Industry/TSTF Standard Technical Specification Change Traveler

Revise Incorrect Bases for Containment Air Temperature

Classification: 2) Bases Only Change

Figure 2
 SURFACE TEMPERATURE vs. TIME FOR
 REPRESENTATIVE MATERIALS INSIDE
 CONTAINMENT FOLLOWING MSLB
 CASE 7

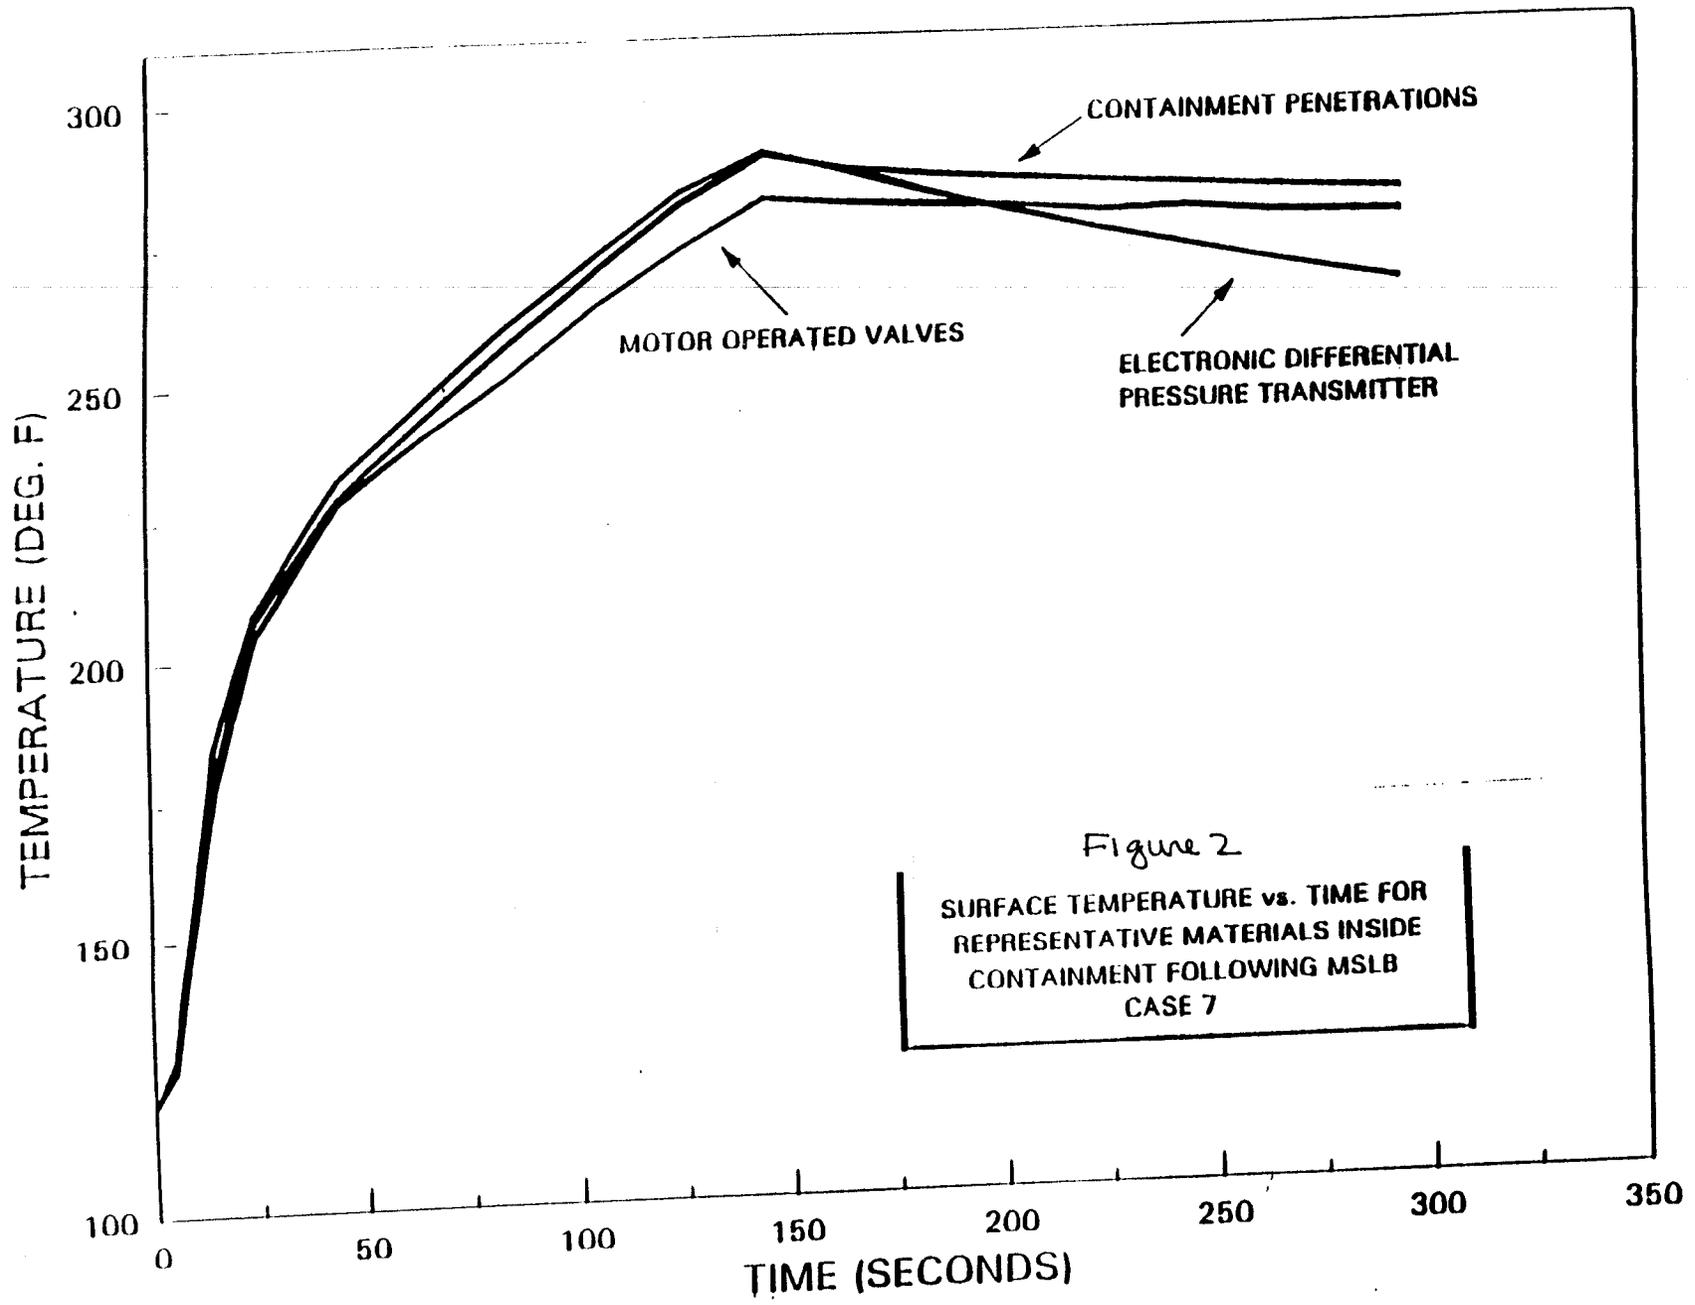
2. The USAR for Wolf Creek was reviewed and the containment analysis engineer queried concerning the temperature profiles for the worst case accident. A review of the temperature profiles for the containment temperature and surface temperature from the main steam line break analysis concluded that the peak accident temperature will exceed the containment design temperature for a short period of time. However, containment structure temperature and equipment surface temperatures remained below the containment design temperature.

3. This information was discussed with a Westinghouse containment analyst to determine if it these temperature profiles were fairly consistent for the Westinghouse plants. The analyst indicated that it was his belief that the temperature will spike above the design temperature. The containment analyst believed that the wording in the STS Bases should be revised.
